EDGEWATER REDEVELOPMENT

SUBMITTAL PACKAGE
URBAN DESIGN COMMISSION

SUBMITTED BY:
LANDMARK X, LLC
A WISCONSIN LIMITED LIABILITY COMPANY

DESIGN EVOLUTION – INTEGRATION OF UDC COMMENTS

BUILDING SETBACK

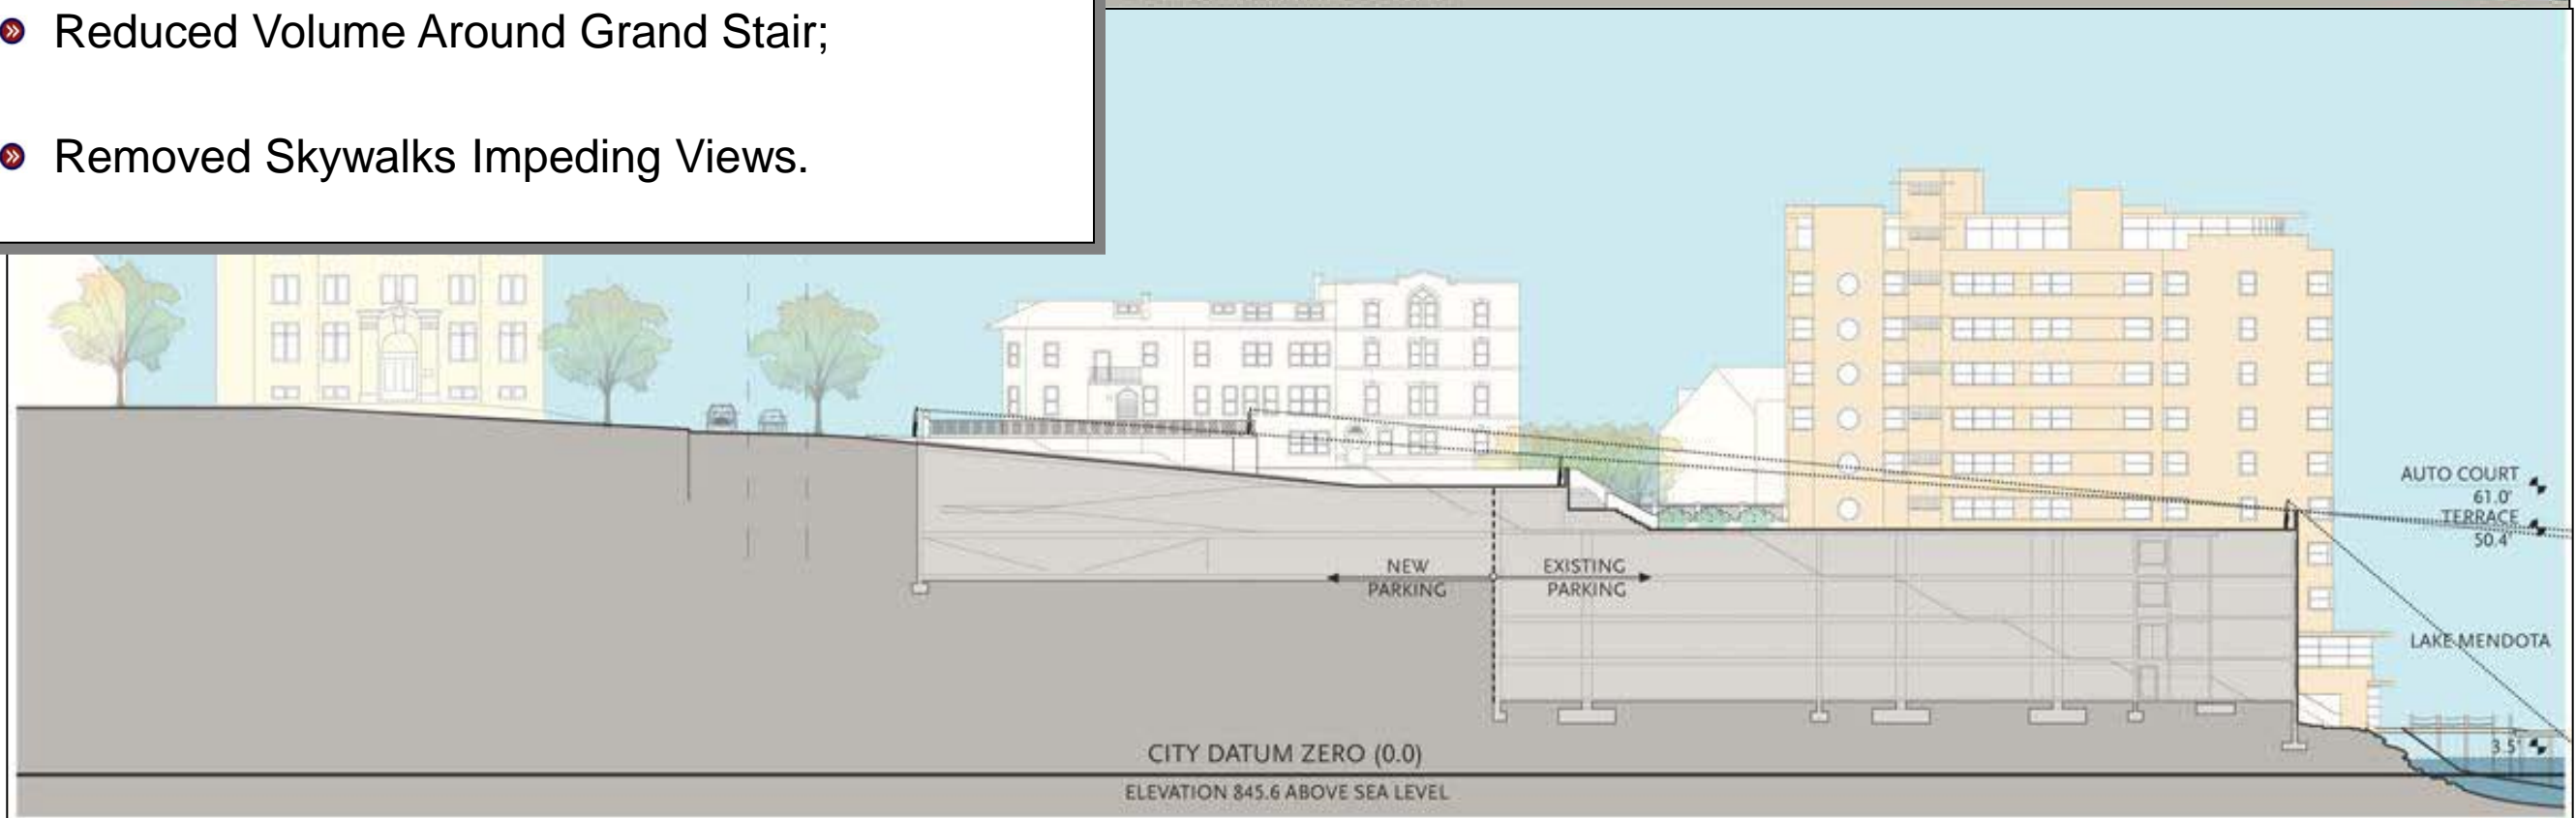
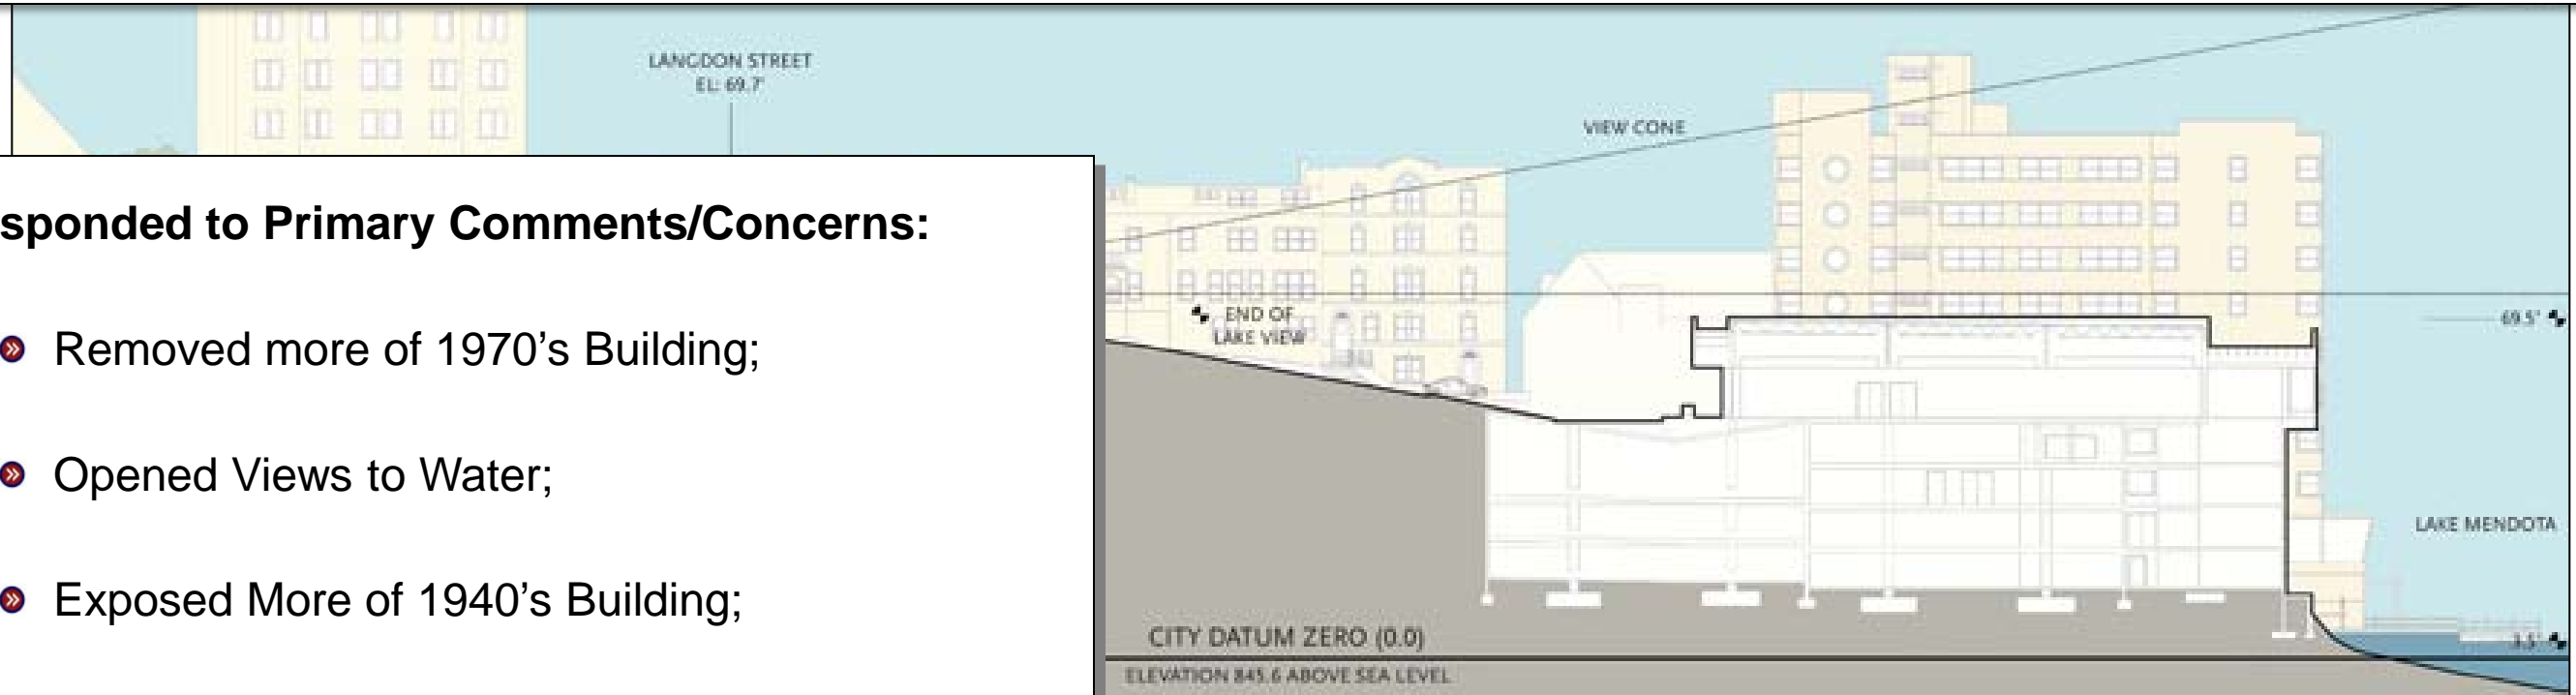
INFORMATION REQUEST: Explain the building setback in relation to Wisconsin Avenue and Langdon Street.

- ⊗ The tower is setback 42'-5" feet from Wisconsin Ave;
- ⊗ Setback is consistent with build-to line on Wisconsin Ave;

- ⊗ The tower is setback 30'-4" from Langdon Street;
- ⊗ Setback is consistent with build-to line on Langdon Street.

VIEWS TO/FROM LAKE MENDOTA

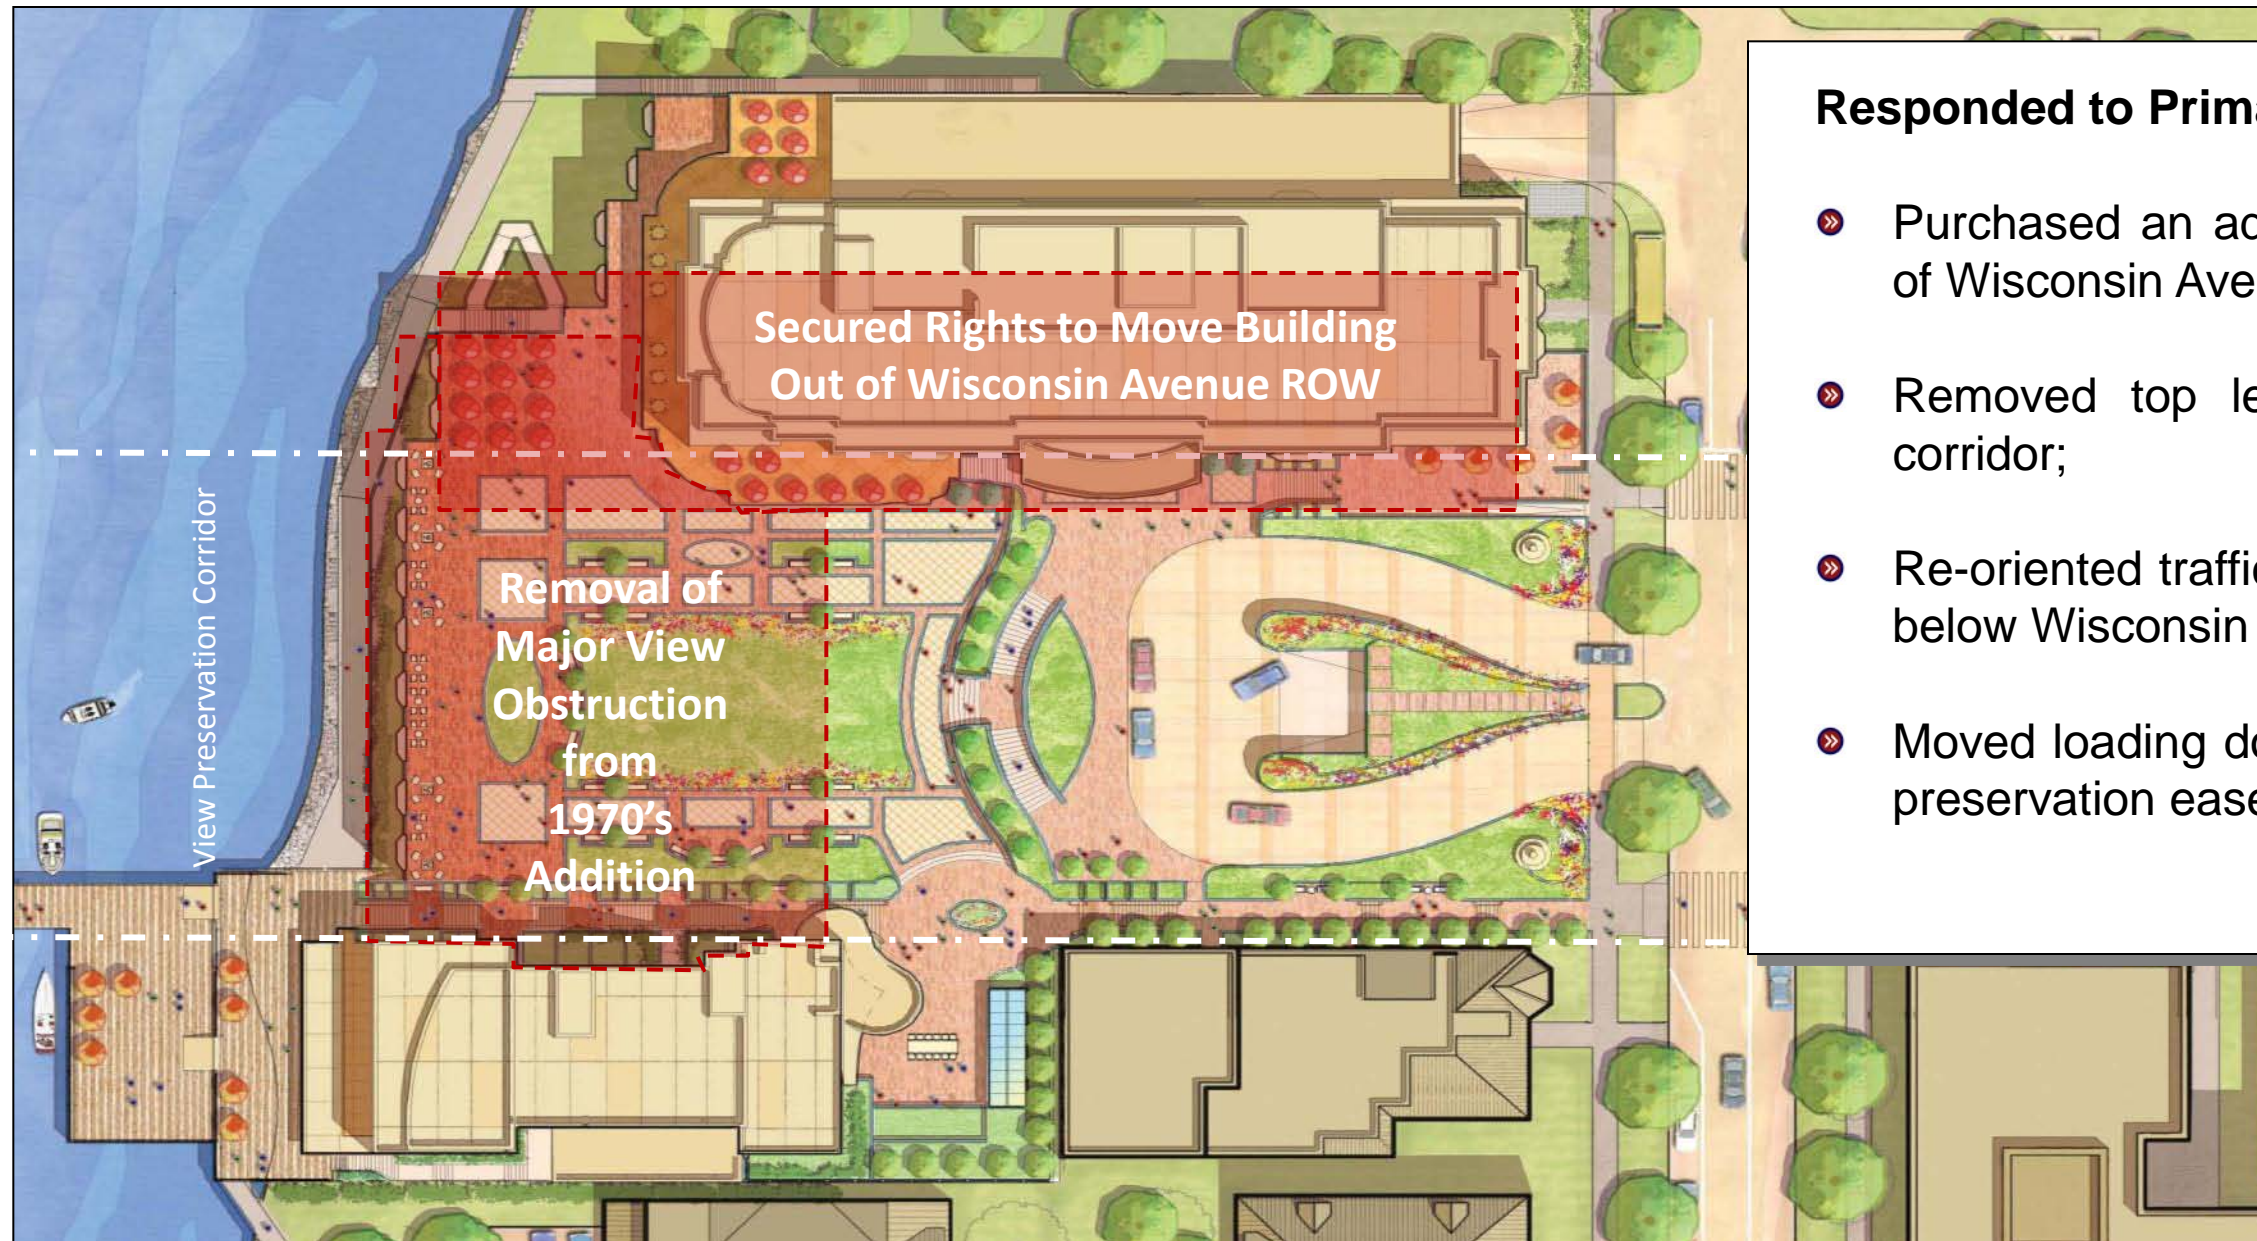
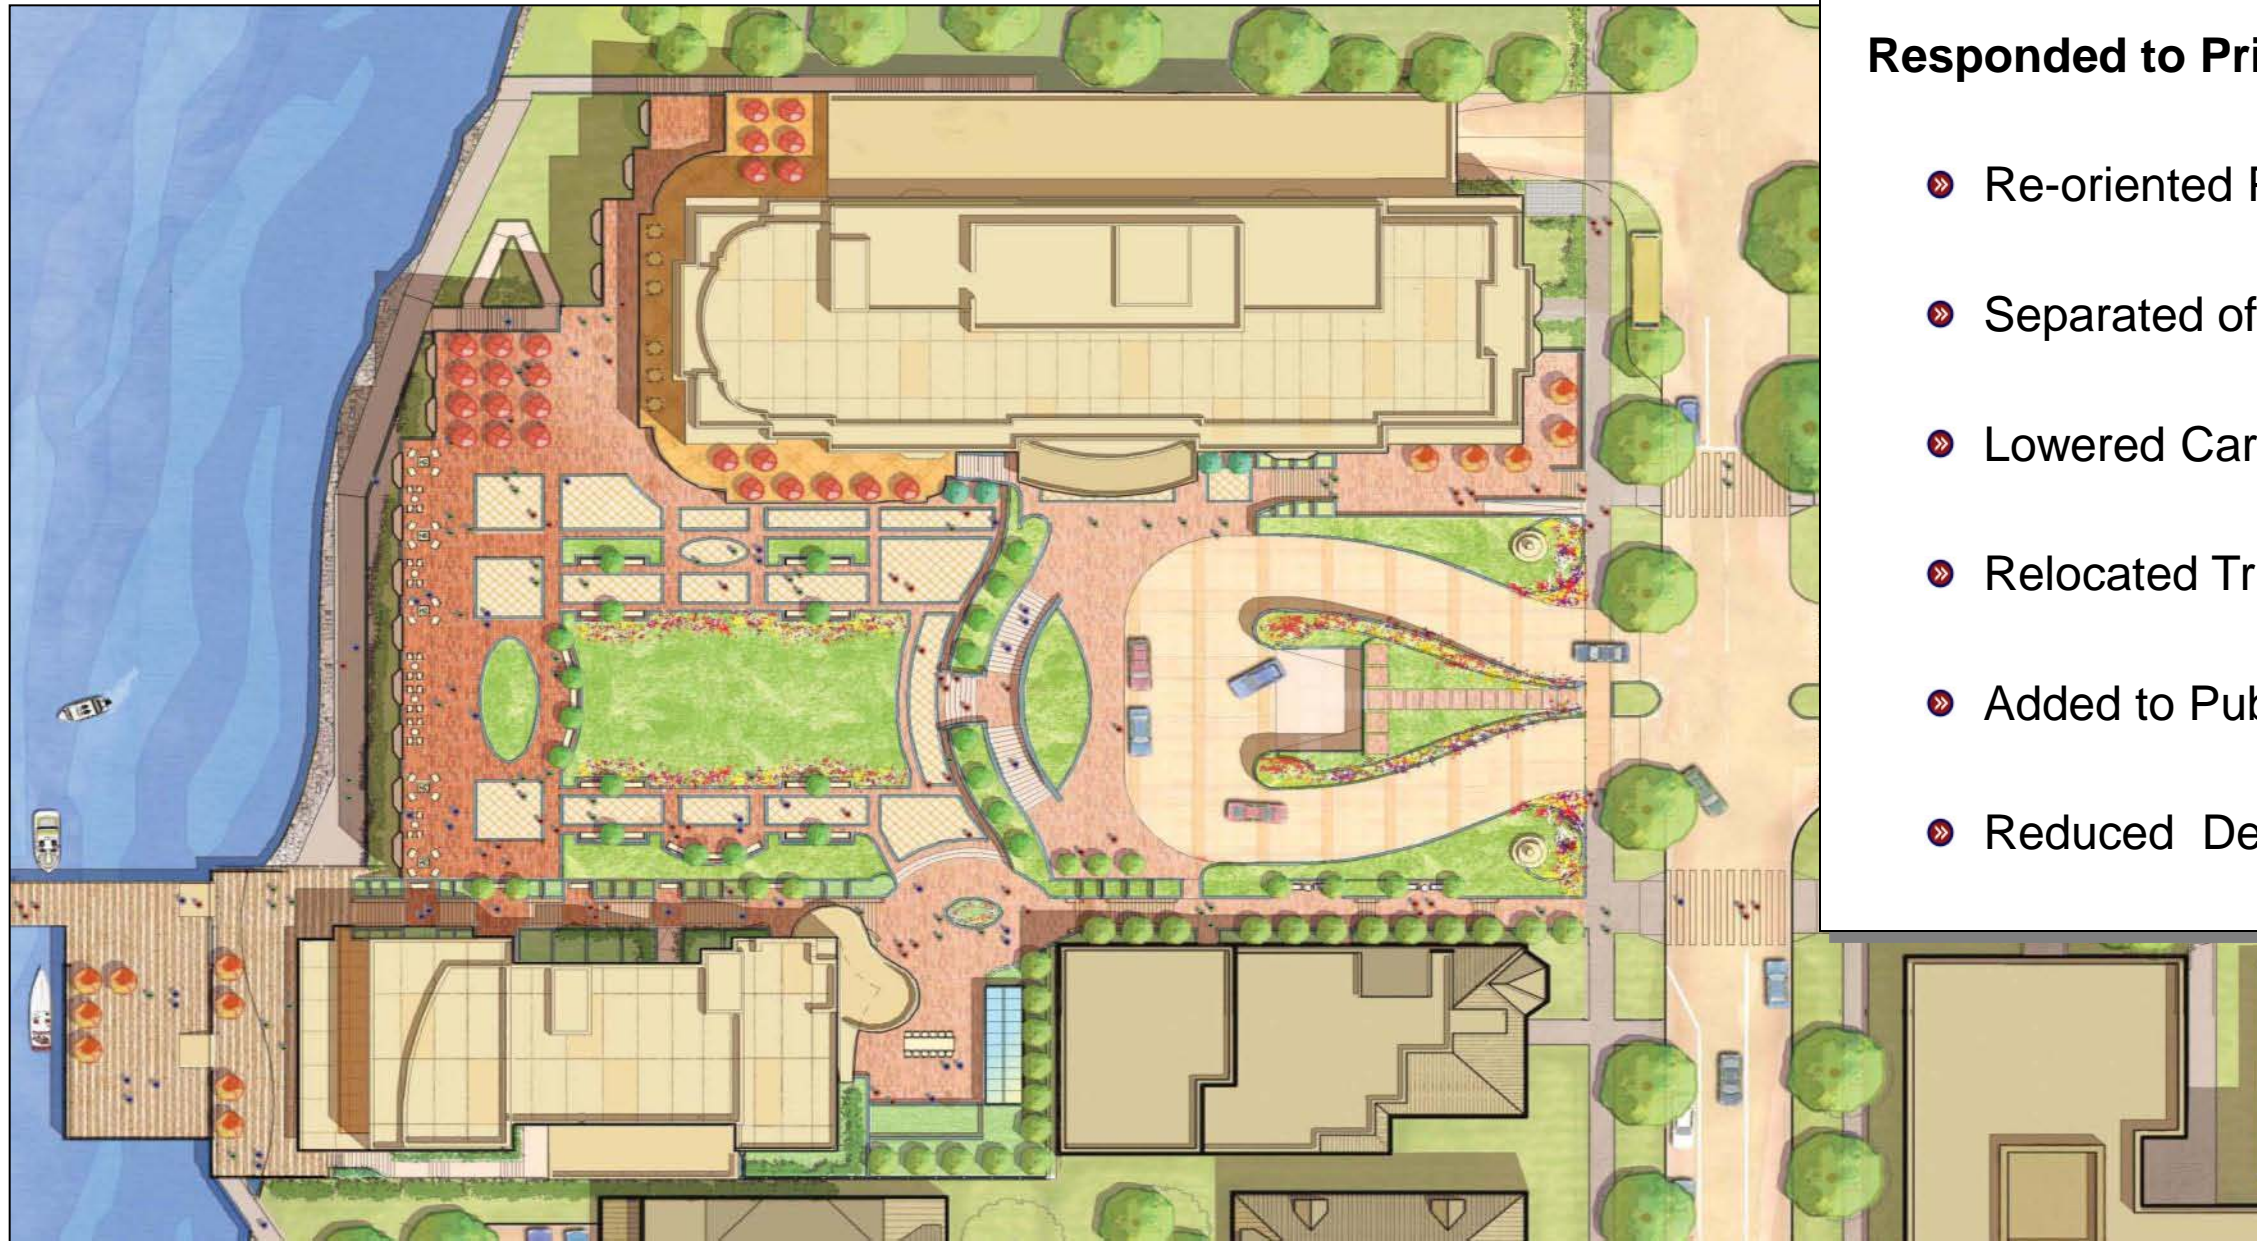
INFORMATION REQUEST: Explain how the developer responded to UDC and other comments to achieve enhanced views to and from the lakefront.

INFORMATION REQUEST: Explain primary changes in design that have allowed for opening of view corridor

- » Removed more of 1970's Building;
- » Opened Views to Water;
- » Exposed More of 1940's Building;
- » Reduced Volume Around Grand Stair;
- » Removed Skywalks Impeding Views.

- Purchased an additional 60 FT to move building out of Wisconsin Avenue right-of-way;
- Removed top level of 1970's building from view corridor;
- Re-oriented traffic patterns to lower cars and drop-off below Wisconsin Avenue view corridor;
- Moved loading dock and bus drop-off outside of view preservation easement.
